City of El Paso - City Plan Commission Staff Report

Case No: SUSU12-00002 Homestead Meadows South Unit Two Replat

"D"

Application Type: Resubdivision Combination

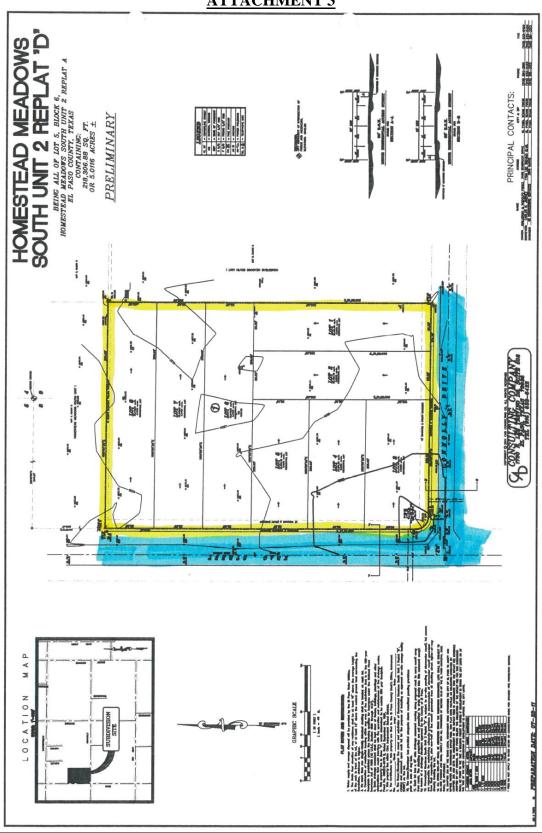
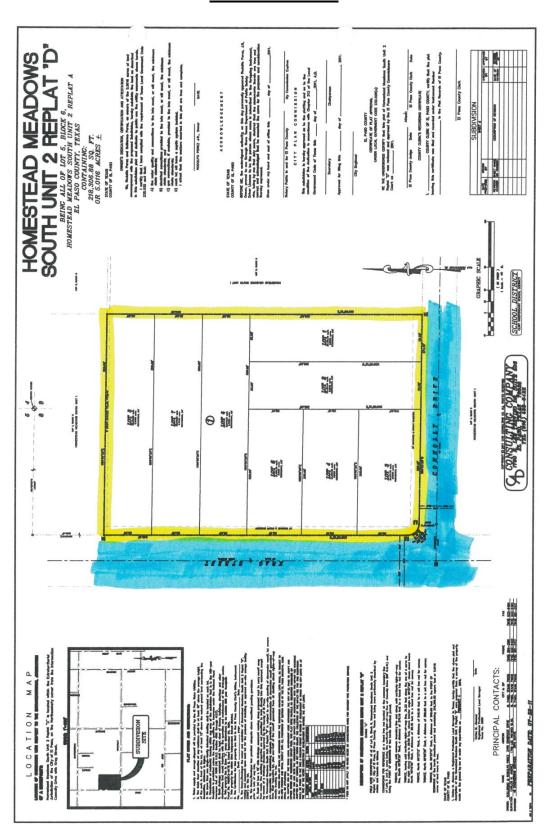
- 1. Clarify Location Map Scale.
- 2. Provide a note on the face of the plat indicating that postal delivery service within the subdivision will be provided using neighborhood delivery and collection box units.

- 1. Revise plat note No. 1 to reflect that only water supply will be provided by El Paso Water Utilities.
- 2. Make the following changes on the Final Engineering Report Page:
- Replace Homestead Municipal Utility District with El Paso Water Utilities every time it appears on the text.
- Replace registered plumber/contractor with El Paso Water Utilities.
- Contact El Paso Water Utilities New Installation Department to obtain updated meter connection costs to be reflected on the Engineering Report.
- Revise proposed date for water connections to be installed.
